UNITED STATES PATENT AND TRADEMARK OFFICE

Office Action Summary

09/909,715

DETAILED ACTION

FIG. 5

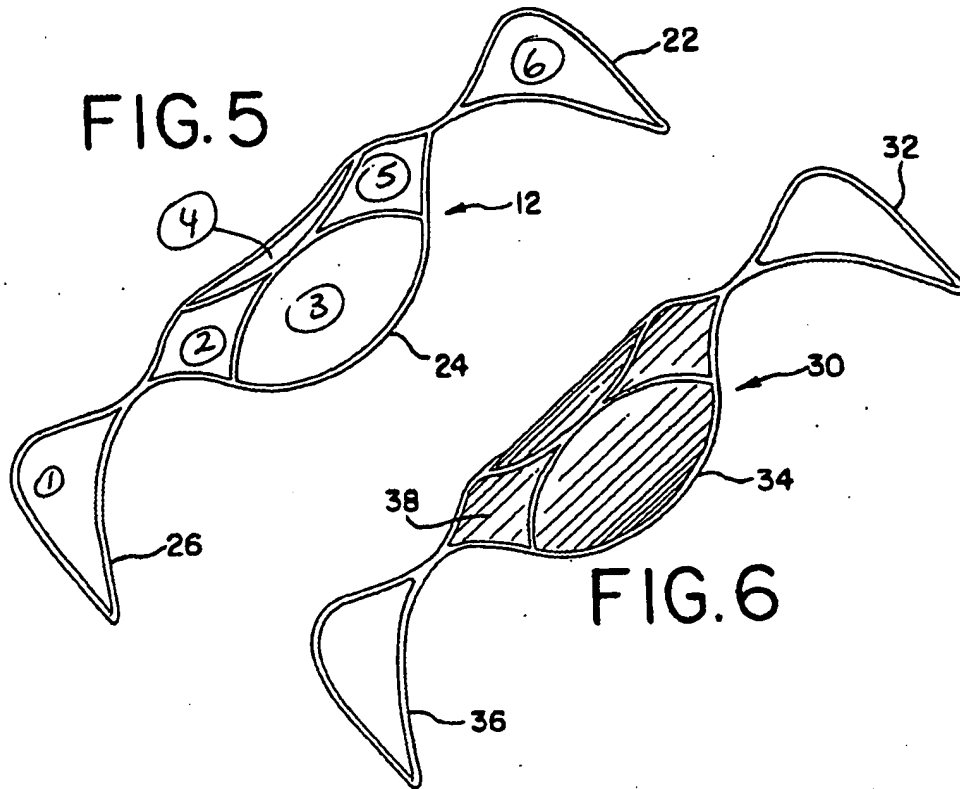
2. Claims 95-100 are rejected under 35 U.S.C. 102(e) as being anticipated by U.S. Patent No. 6,613,074 B1 to Mitelberg et al. Mitelberg discloses an apparatus for treating vascular aneurysms including six fenestrations, i.e. windows or openings, as labeled in Attachment A. The body of the stent is cylindrical and blood flows through the internal lumen. A reactive material (hydrogel) [column 5, lines 32-33] is applied to fenestrations 2-4 (“not all”), as shown in Figure 6. Hydrogels react in the presence of liquids, in this case blood. Hydrogel (38) “is intended to significantly reduce...the flow into the aneurysm” [column 5, lines 26-29]. In other words, applying a hydrogel to the fenestrations increases the resistance of blood flow through the fenestrations (compared to naked frame shown in Fig. 5), but *still allows some blood to flow into the aneurysm*. Mitelberg’s stent is radially expandable to be the size of the interior lumen of the blood vessel [Column 2, lines 38-39]. Mitelberg’s hydrogel expands with the stimulus of being exposed to a liquid (blood).

Fenestrations
① ② ③ ④ ⑤ ⑥
